Addendum 124 – UN Regulation No. 125

Revision 2 – Amendment 3

02 series of amendments – Date of entry into force: 22 June 2022

Uniform provisions concerning the approval of motor vehicles with regard to the forward field of vision of the motor vehicle driver

"Annex 2

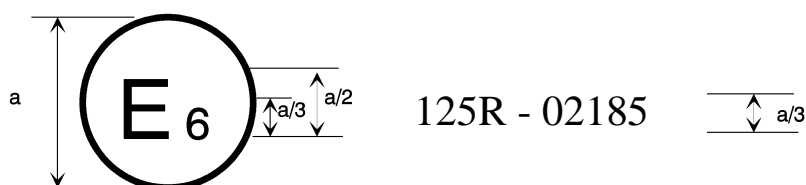
Annex 2, amend to read:

Arrangements of approval marks

(see paragraphs 4.4. to 4.4.2. of this Regulation)

a = 8 mm min

The above approval mark affixed to a vehicle shows that the vehicle type concerned has been approved in Belgium (E 6) with regard to the driver's forward field of vision pursuant to UN Regulation No. 125. The first two digits of the approval number indicate that the approval was granted in accordance with the requirements of UN Regulation No. 125 as amended by the 02 series of amendments."
